NO. FAS-006

Fuji Heavy Industries, LTD.

1. SUBJECT : Improvement of nose cowling bracket.
2. AIRCRAFT AFFECTED : FA-200, Serial No. 12 through 75 airplanes.
3. PRIORITY : Desirable.
4. REASON : To avoid the crack on the bracket fixing the upper and lower nose cowling.
5. DESCRIPTION : Replace the bracket to the new one.
(P/N 200-411051-009, -010)
6. ACCOMPLISHMENT : On any time.
7. APPROVAL : Not applicable.
8. PARTS REQUIRED:

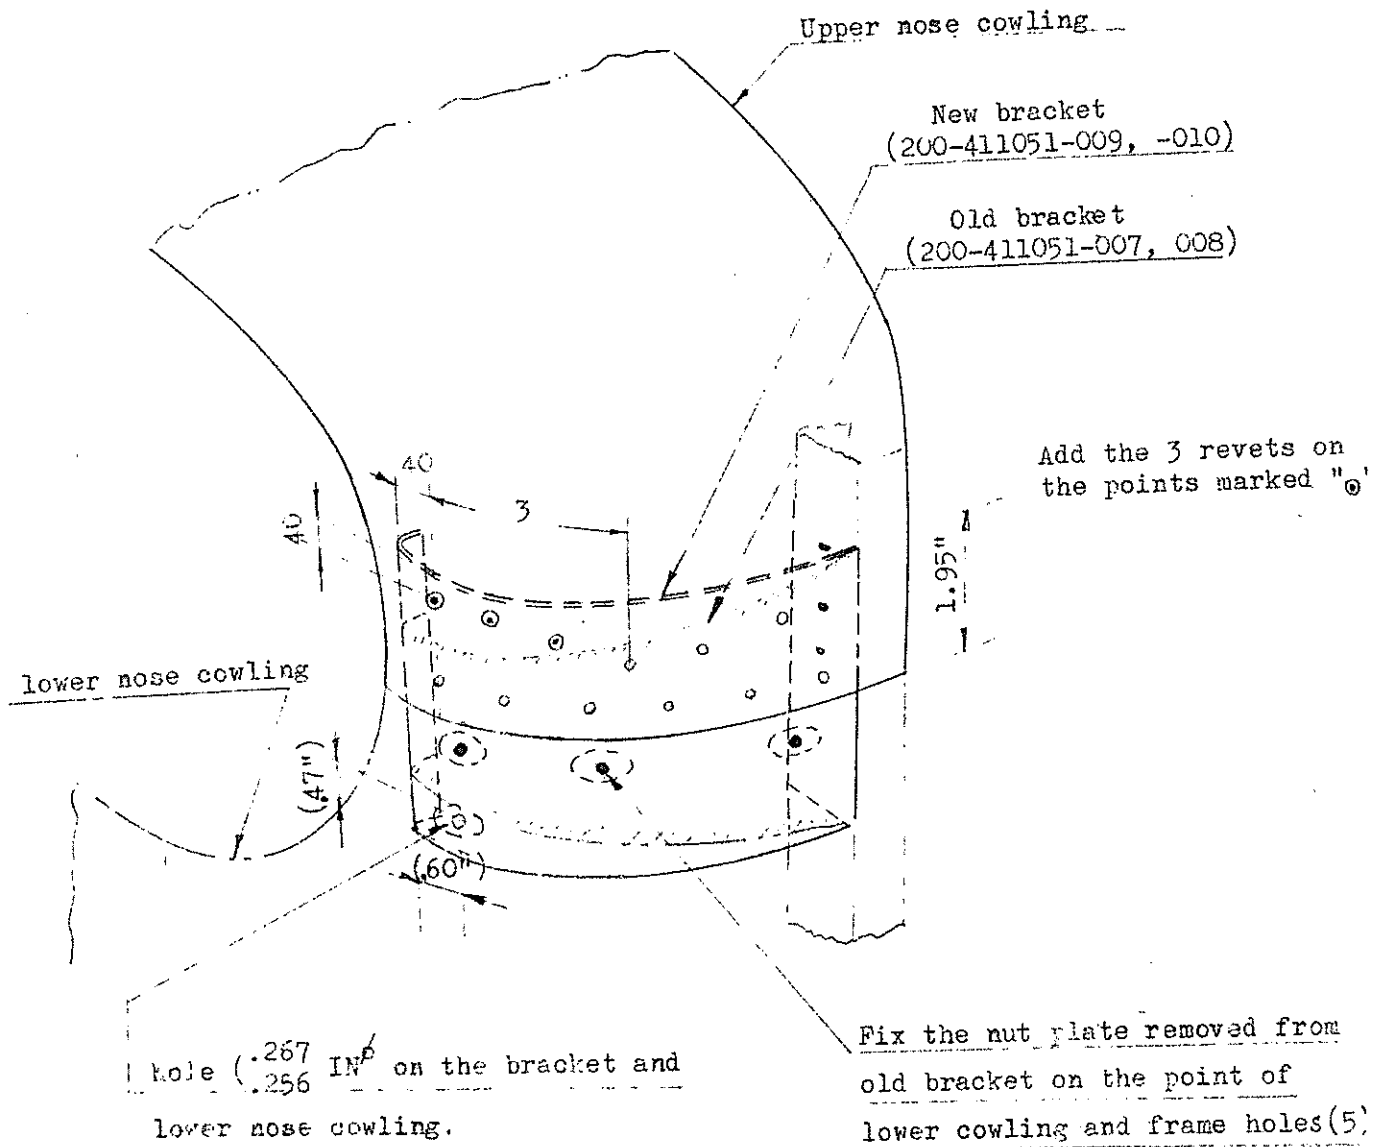
- (1) Remove the upper cowling.
- (2) Replace the bracket revetted on the upper nose cowling fixing the upper and lower nose cowling, to new one. (200-411051-009, -010)
- (3) Install the upper nose cowling. On this time, make a hole $\begin{matrix} .267 \\ .525 \end{matrix}$ IN^Ø on the lower cowling on the same point of the nut plates on the bracket and fasten the screw, AN525-416R8.
